## Index 102-613 Multilane Roadway, Lane Closure

## **ORIGINATION**

## COMMENTS AND RESPONSES

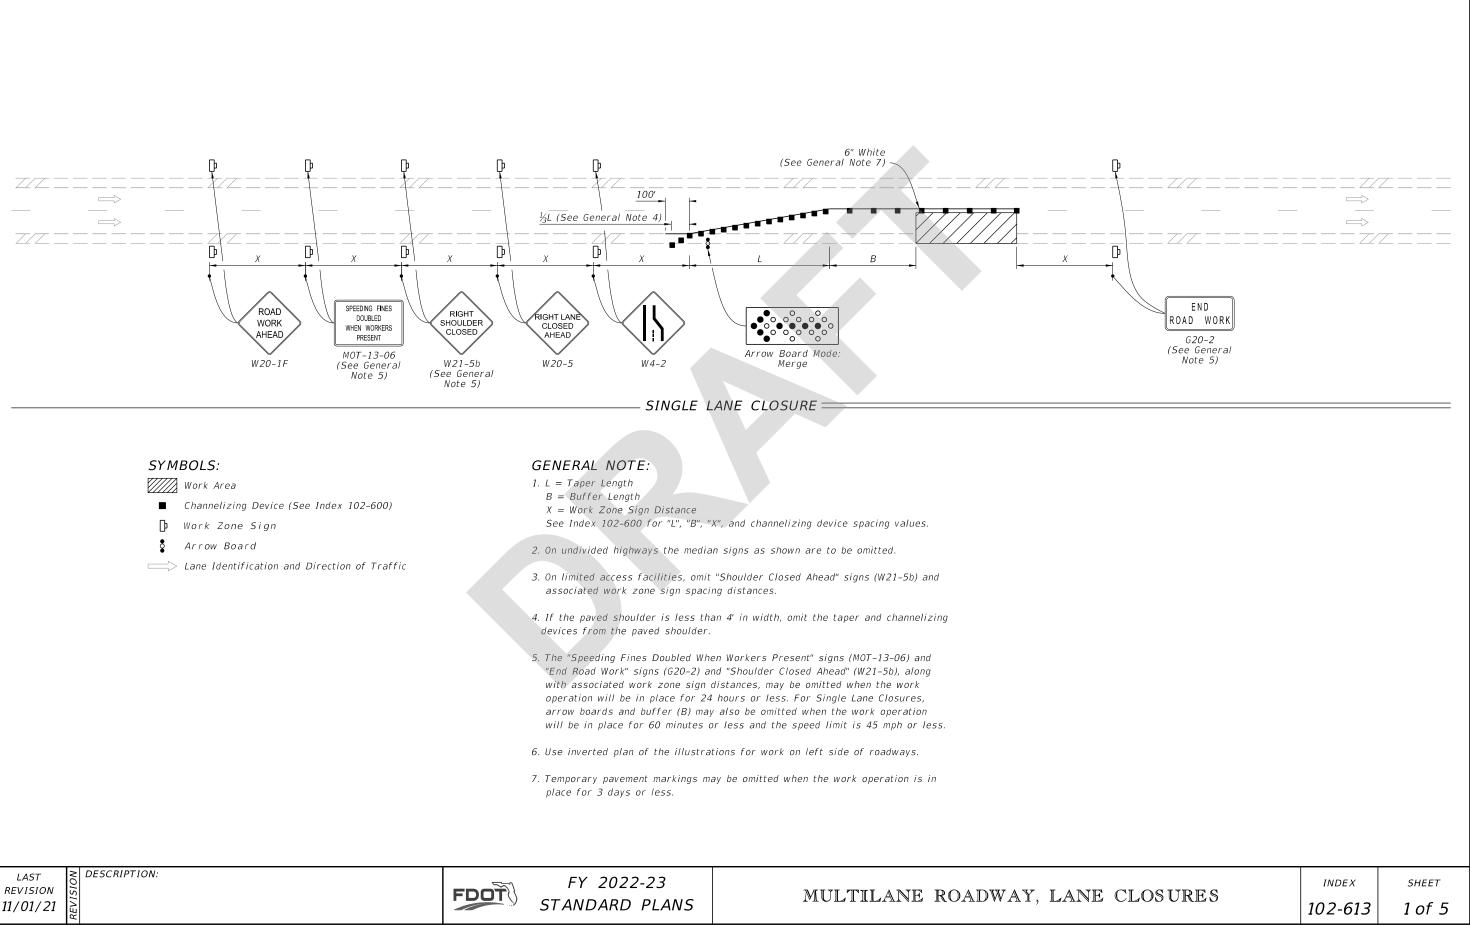
**COMMENT:** Is the 4-ft paved shoulder provision intended to apply to all roadway types (i.e., limited access facilities vs. Arterials/Collectors)?

**RESPONSE:** No, only 4' or wider paved shoulder on non-limited access facilities are considered "Bicycle Facilities".

**Change Made:** Instead of revising the Note further, it has been decided to remove the redundant note from all relevant 102 Series Indexes. The FDM provides guidance on bicycle accommodations and Specification 102-3.4 will be updated to clarify the definition of a "Bicycle Facility" (i.e., existing marked Bicycle Lane or a 4' or greater paved shoulder on non-limited access roadways). **Note Deleted.**
